CITY OF ST. PETERSBURG, FLORIDA

STAFF REPORT

Community Planning and Preservation Commission Certificate of Appropriateness Request

REQUEST: Review of a Certificate of Appropriateness for the construction of a

Figure 3: Proposed site plan with the new addition, outlined in red.

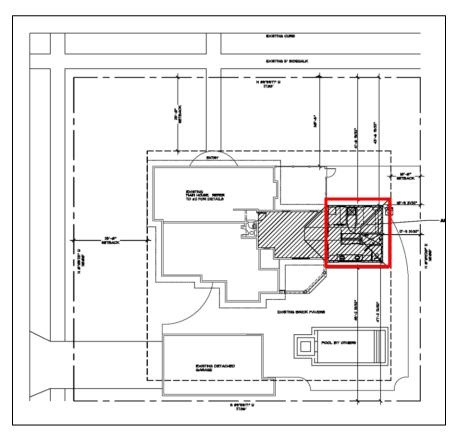
The proposed addition will be located to the side of the main building. Normally, it is recommended that additions be located in the rear to not be as visually intrusive. The main house doesn't have any room for the addition to be located in the rear, as a historic garage is directly behind the house. Also, the side addition, attached onto the 1936 addition, will lead to less loss of historic materials on the main house.

Consistent This property is one of the few in the district that is located on a double lot, allowing for a side addition that will be more visually compatible.

Figure 3: Proposed elevations with the new addition.

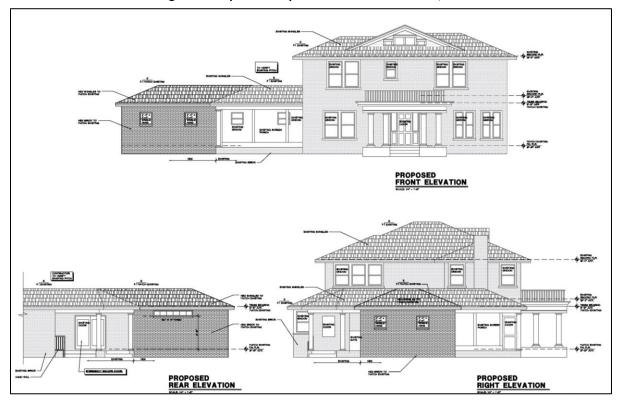
Consistent The proposed addition will have a roof peak of approximately 14.25'. This is consistent with the height of the 1936 addition.

The proposal includes using windows on the front that match the 1936 addition. The windows will be small one-over-one windows, much shorter than the windows in the main house.

The front façade will include only two small windows, matching the fenestrations in the 1936 façade. Staff feels it would be more appropriate to match the fenestrations in the main house, but understands that since the proposed addition will be used as a closet, that the applicant would prefer smaller windows.

Consistent The proposed roof will have a hipped roof that matches the 1936 addition and will be compatible with the main house and neighborhood.

- 1. Windows will be installed to be setback within the wall plane and feature a reveal of at least two inches.
- 2. All other necessary permits shall be obtained. Any additional work shall be presented to staff for determination of the necessity of additional COA approval.
- 3. This approval will be valid for 24 months beginning on the date of revocation of the local Emergency Declaration.
